ADDENDUM 01

Roseville Joint Union High School District
West Park High School, Phase 2 – Increment 1
DSA Application Number: 02-118062

DLR Group Project No: 75-19101-00

3 A5.S.1 **BUILDING SIERRA - EAST ELEVATION**
SCALE: 1/8" = 1'-0"

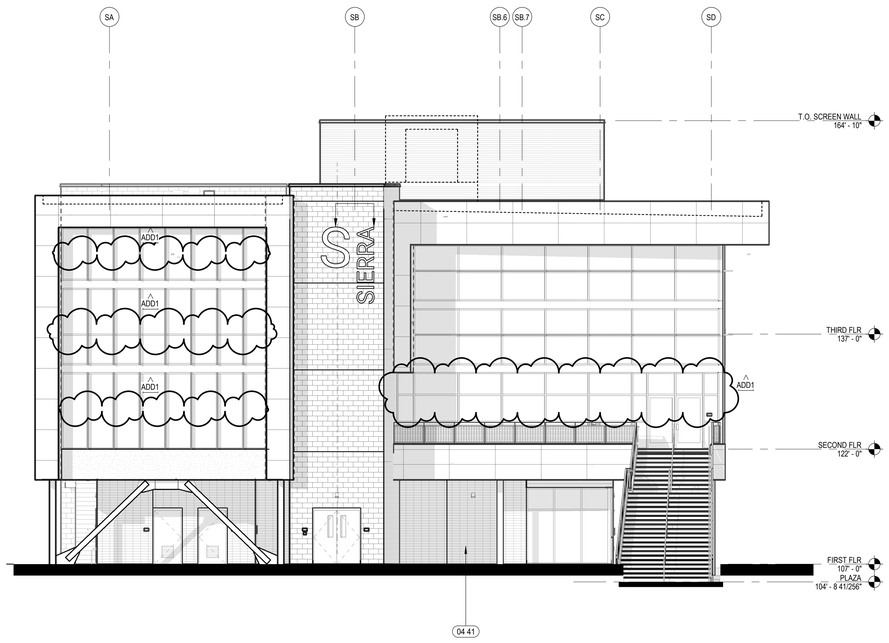
RFI 19 ..... Building S Eastern Classroom S207's storefront type 17 horizontal mullions modeled incorrectly (has extra horizontal mullions in all three panels)
Answer..... *REMOVED extra horizontal mullions from the elevation. See attached sheets A5.S.1 and A9.2.*

20. **Sheet A5.S.1 - EXT ELEVS – BLDG S**
    A. *East Elevation – REVISED location of horizontal storefront mullion at door head to accommodate storefront door*
    B. *East Elevation at Classroom – REMOVED horizontal mullions from storefront systems as indicated*

3 A12.1 E-ELEVATION F104/F105
SCALE: 1/4" = 1'-0"

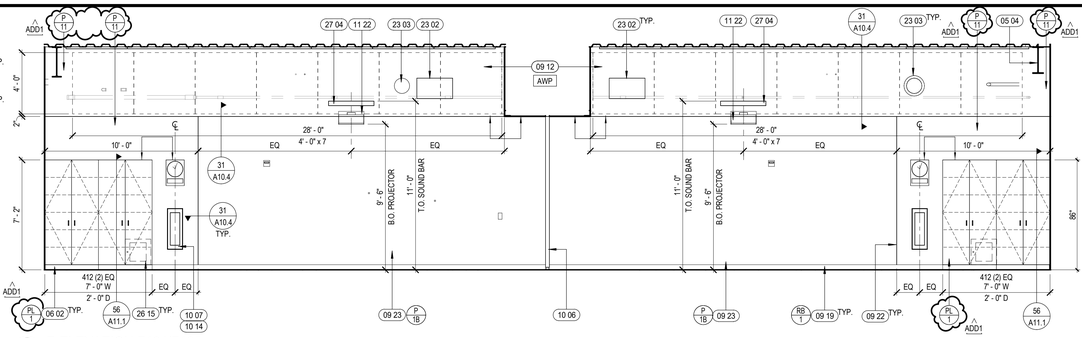
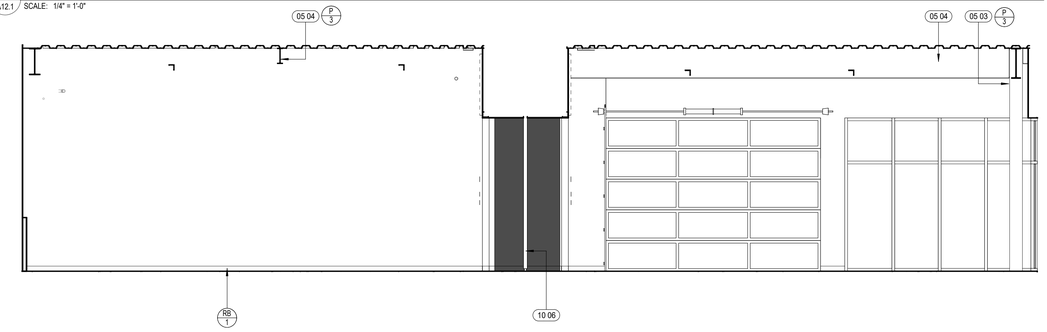
RFI 29 ..... Page A12.1 – Interior Elevations – Bldg F. What is the Interior Finish Legend ML/1? Please clarify F104 – 3/A12.1, F105 – 3/A12.1, F105 – 6/A12.1, S104 – 3/A12.5, and S105 – 3/A12.5.
Answer..... *ADDED PL-1 material to the Interior Finish Legend, REPLACED all ML-1 references with PL-1*

23. **Sheet A12.1 - INT. ELEVATIONS – BLDG. F**
    A. *3/A12.1 - REVISED material reference ML-1 to be PL-1*
    B. *ADDED interior elevations 17/A12.1, 18/A12.1 & 19/A12.1*
    C. *ADDED keynote 12 09 Laboratory Casework to 9/A12.1*

17 A12.1 F110 SCIENCE STORAGE - EAST
SCALE: 1/4" = 1'-0"

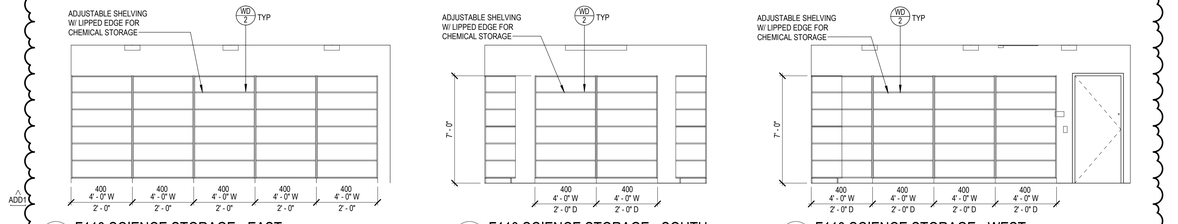
RFI 03 ..... Reference specification 10 56 13 for Metal Shelving. Please confirm where this scope of work occurs as none could be located.
Answer:..... ADDED metal shelving in F110 Science Storage.

3 A12.5 E-ELEVATION S104/S105
SCALE: 1/4" = 1'-0"

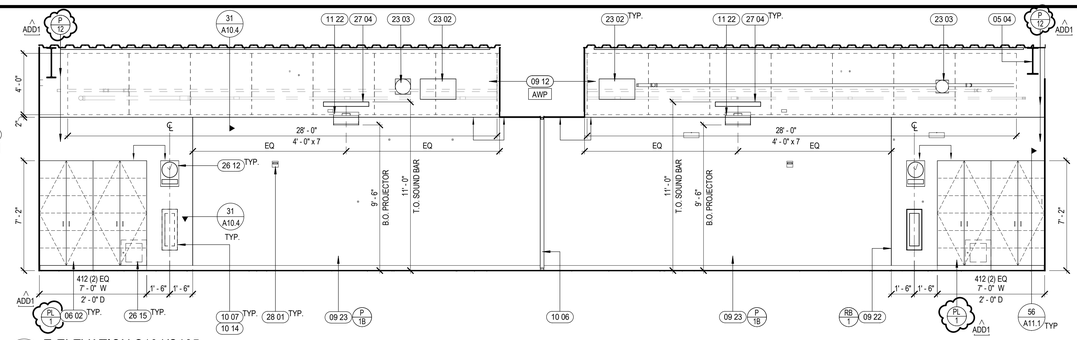
27. **Sheet A12.5 - INT. ELEVATIONS – BLDG. S**
    A. *3/A12.5 - REVISED material reference ML-1 to be PL-1*
    B. *ADDED keynote 12 09 Laboratory Casework to 10/A12.5*

FINISH FLOOR PLAN - BLDG F - 2ND FLOOR

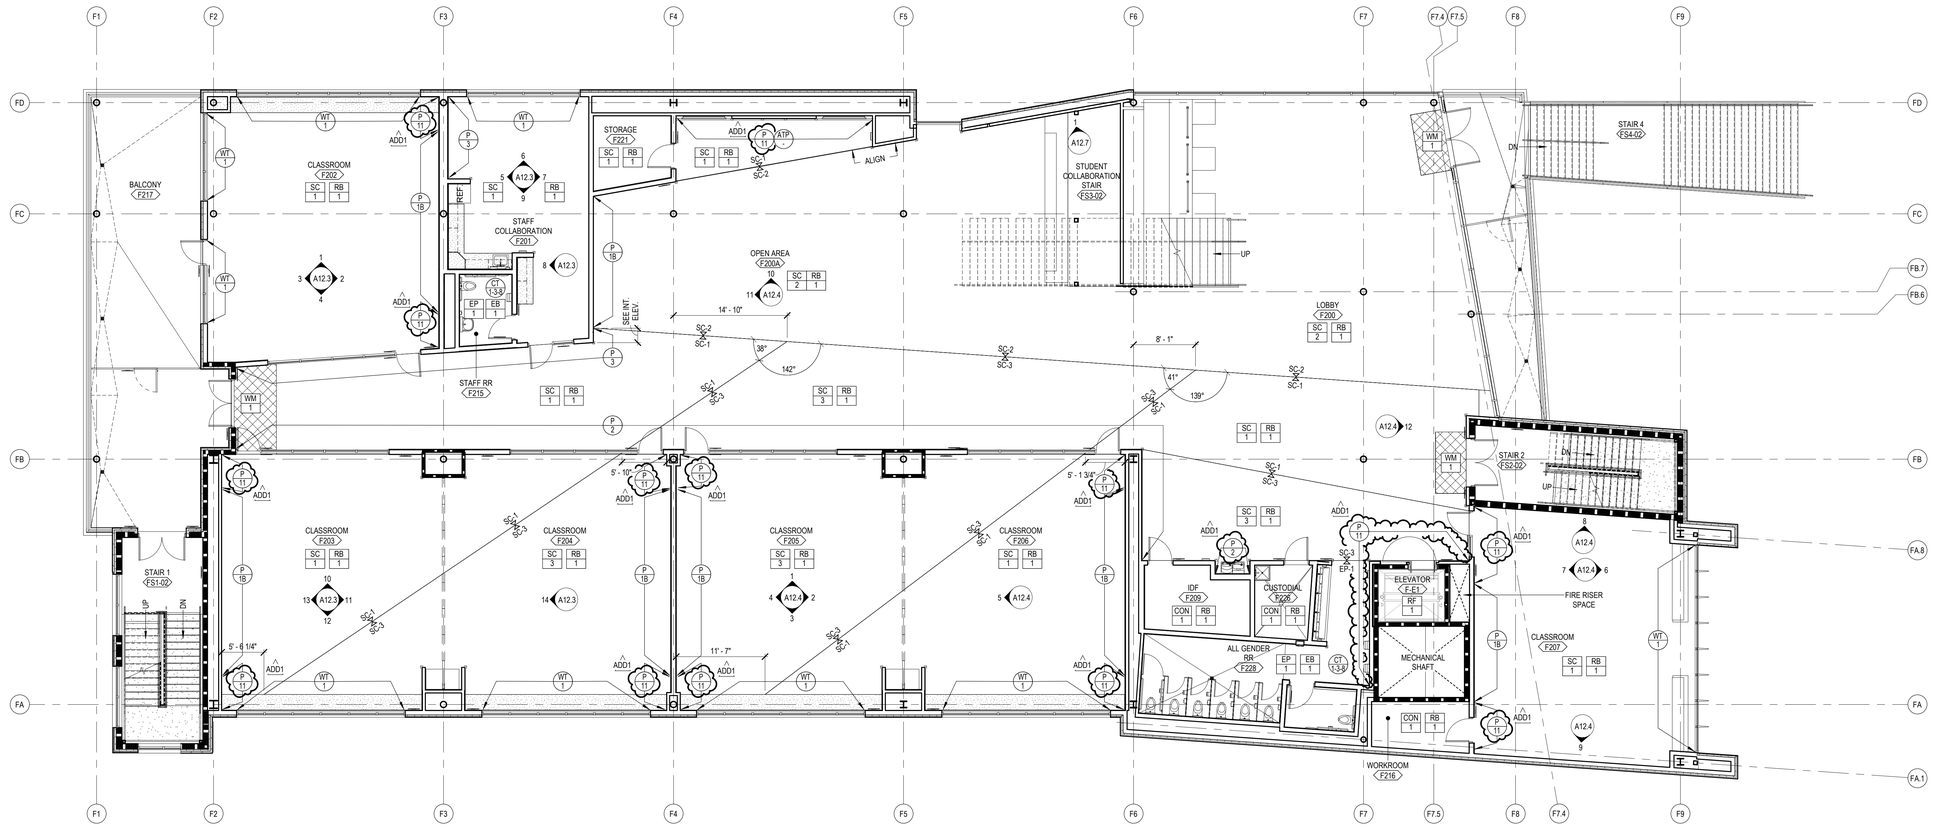
30. Sheet A13.F2.1 - FINISH FLR PLANS & SCHEDULES – BLDG F – 2ND FLOOR
- *A. ADDED paint accent color P-2 at drinking fountains*
- *B. ADDED paint accent color P-11 at Elevator/All Gender RR walls*

FINISH FLOOR PLAN - BLDG F - 3RD FLOOR

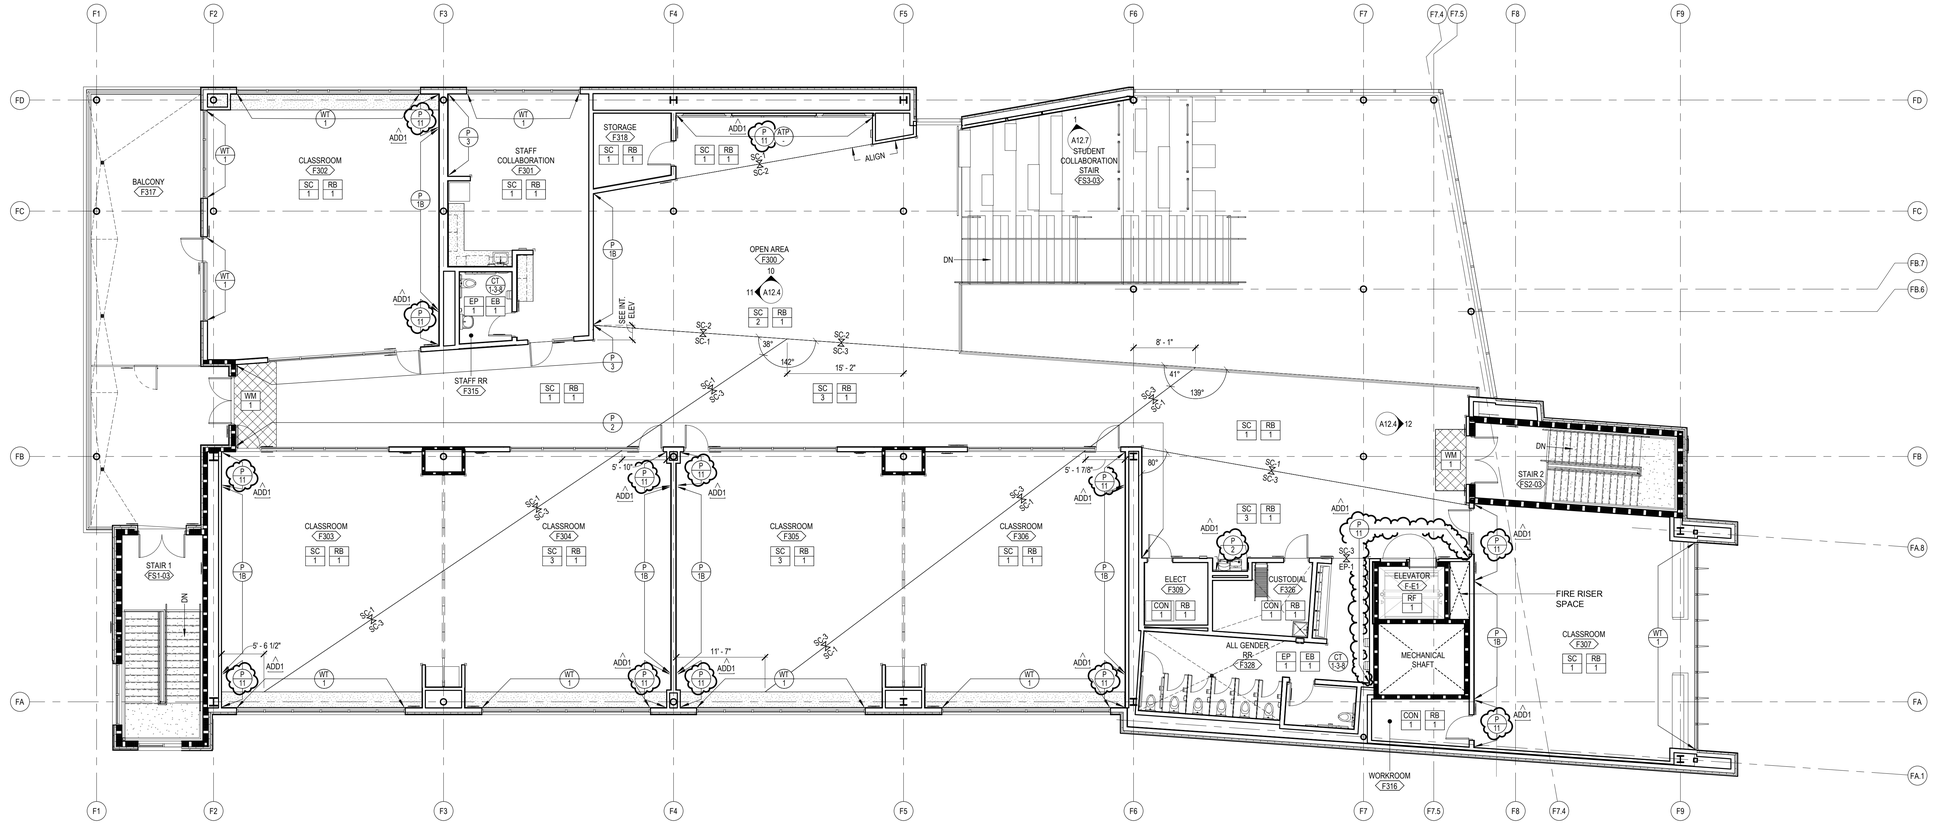
31. Sheet A13.F3.1 - FINISH FLR PLANS & SCHEDULES – BLDG F – 3RD FLOOR
- *A. ADDED paint accent color P-2 at drinking fountains*
- *B. ADDED paint accent color P-11 at Elevator/All Gender RR walls*

FINISH FLOOR PLAN - BLDG S - 2ND FLOOR

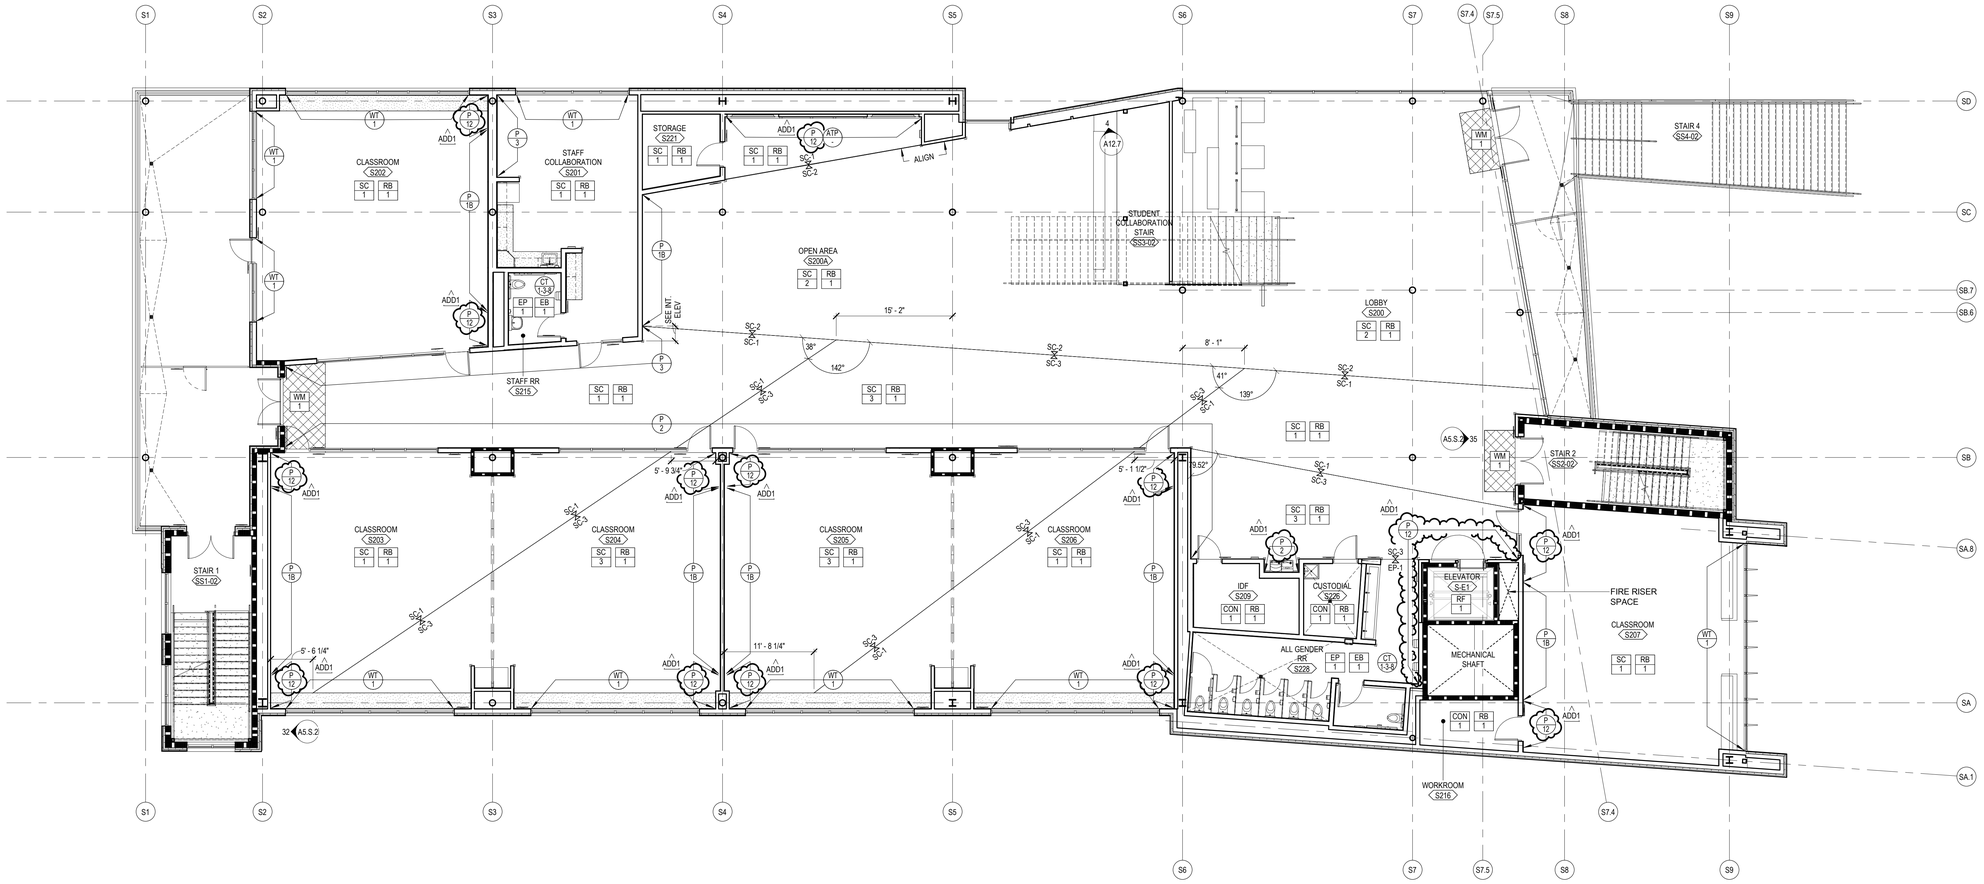
32. Sheet A13.S2.1 - FINISH FLR PLANS & SCHEDULES – BLDG S – 2ND FLOOR
- *A. ADDED paint accent color P-2 at drinking fountains*
- *B. ADDED paint accent color P-12 at Elevator/All Gender RR walls*

FINISH FLOOR PLAN - BLDG S - 3RD FLOOR

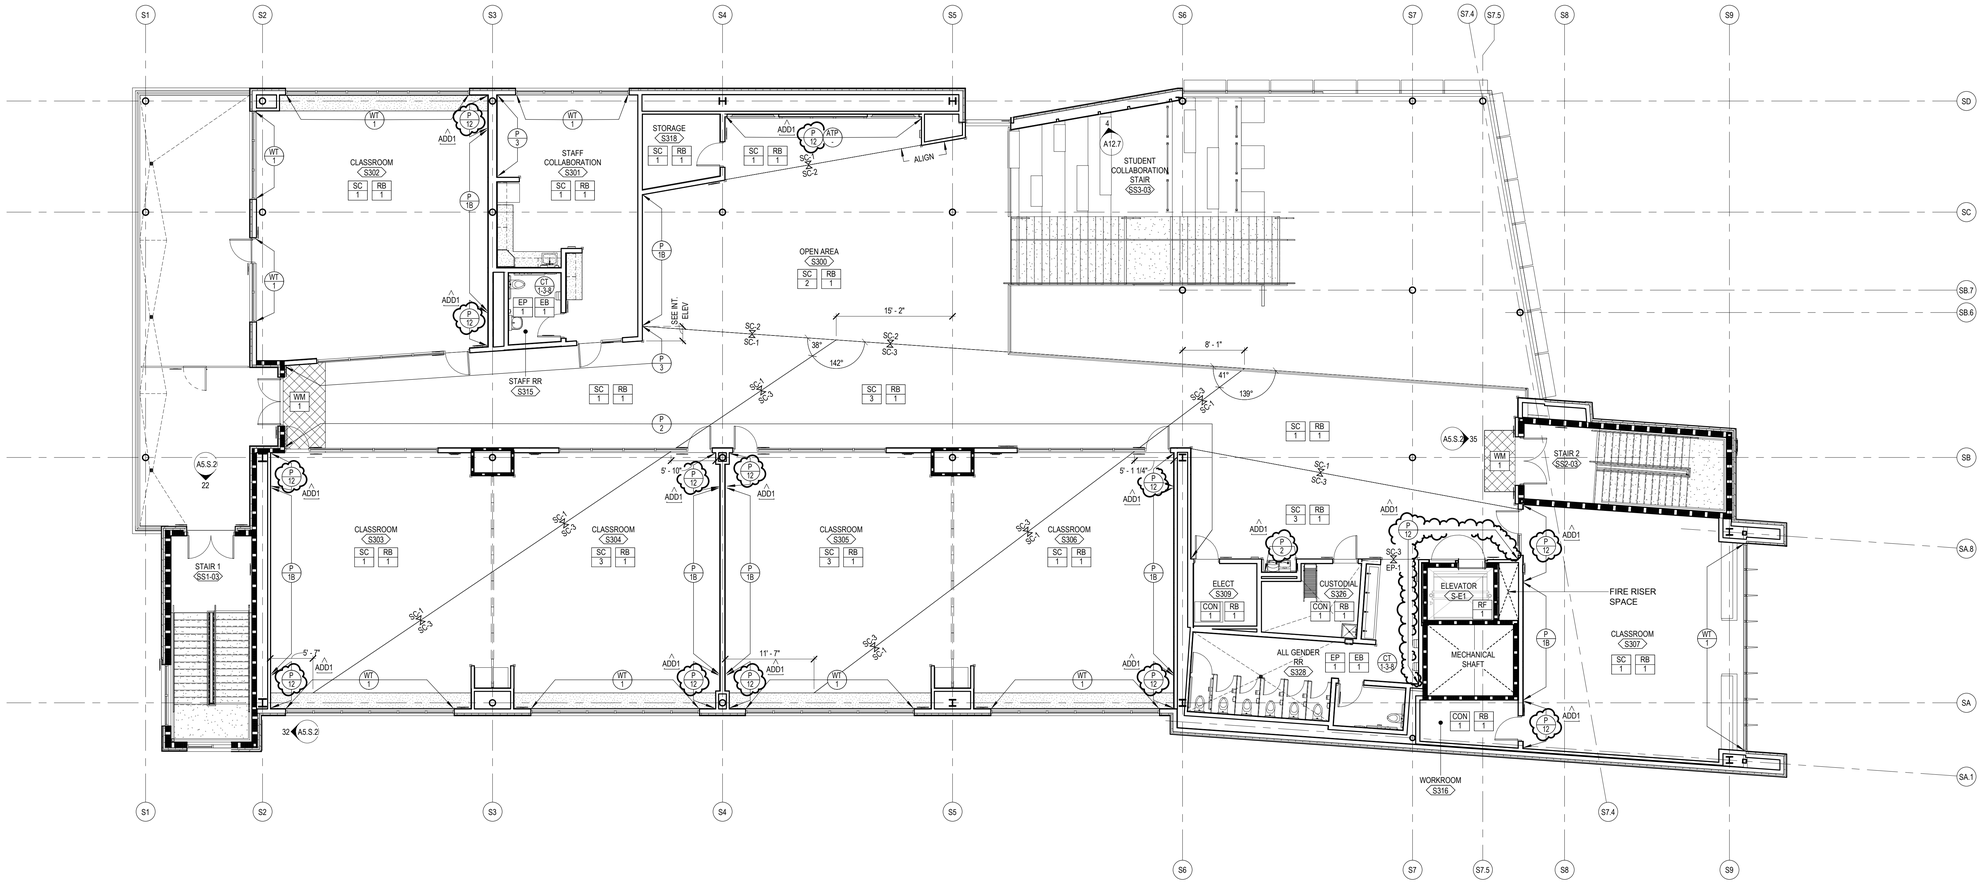
33. Sheet A13.S3.1 - FINISH FLR PLANS & SCHEDULES – BLDG S – 3RD FLOOR
- *A. ADDED paint accent color at P-2 drinking fountains*
- *B. ADDED paint accent color P-12 at Elevator/All Gender RR walls*

1 POWER PLAN - FOOTHILL BUILDING - FIRST FLOOR

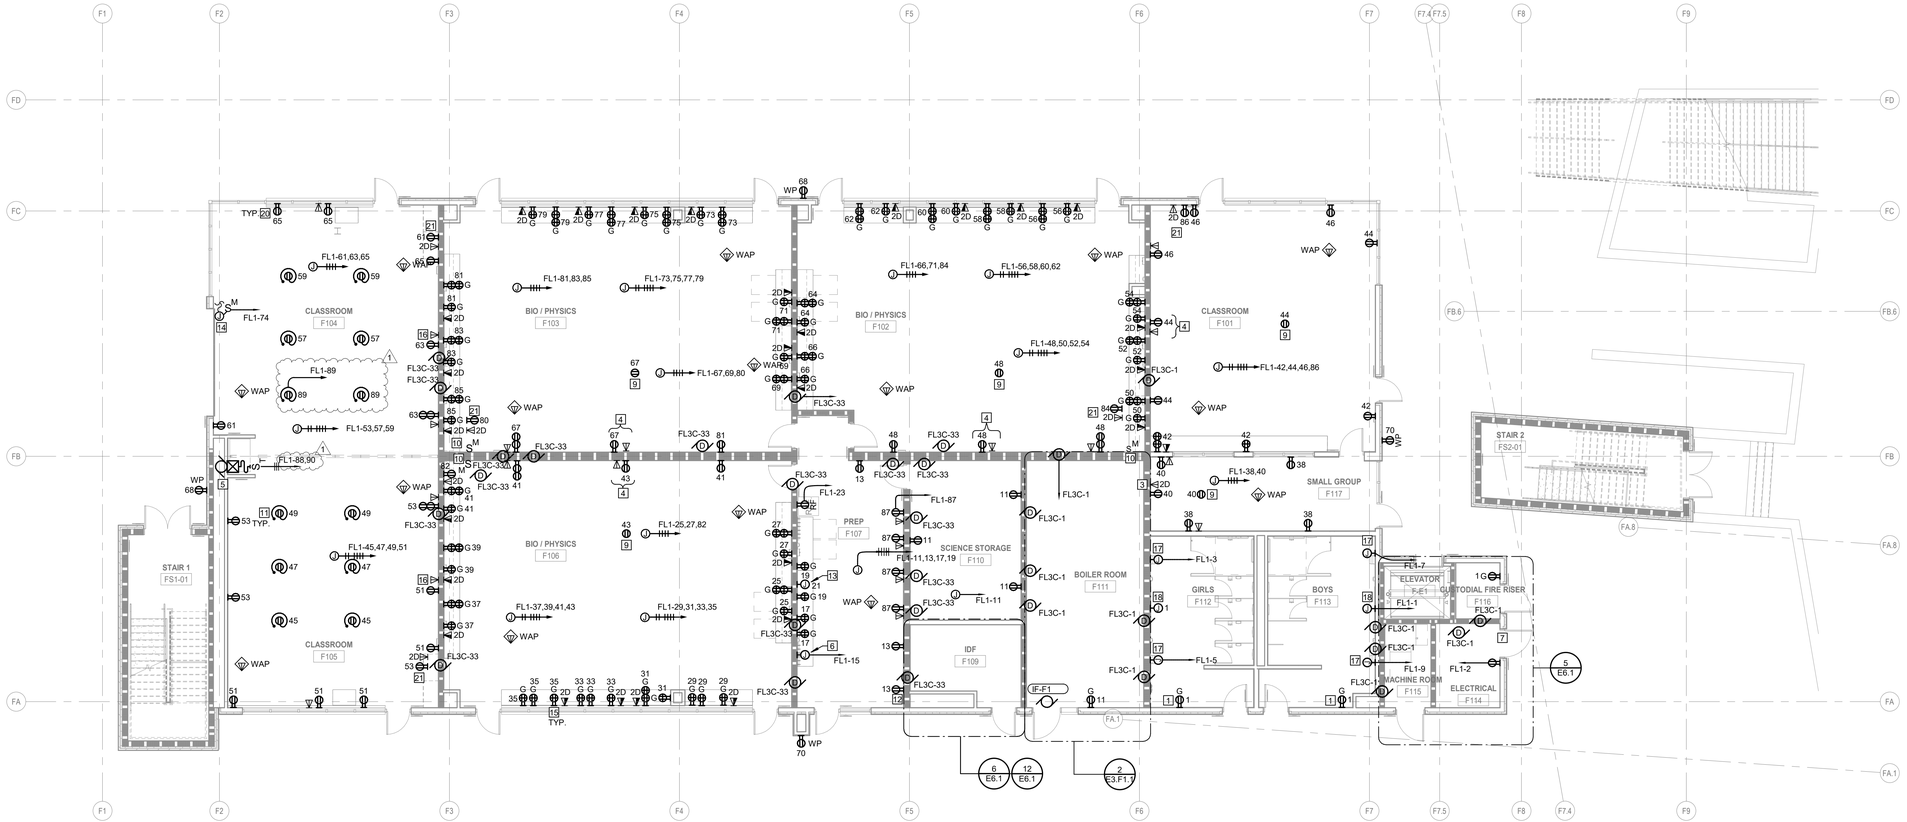
36. SHEET E3.F1.1 – POWER PLAN – FOOTHILL BUILDING – FIRST FLOOR
- *A. UPDATED circuiting for operable partitions*
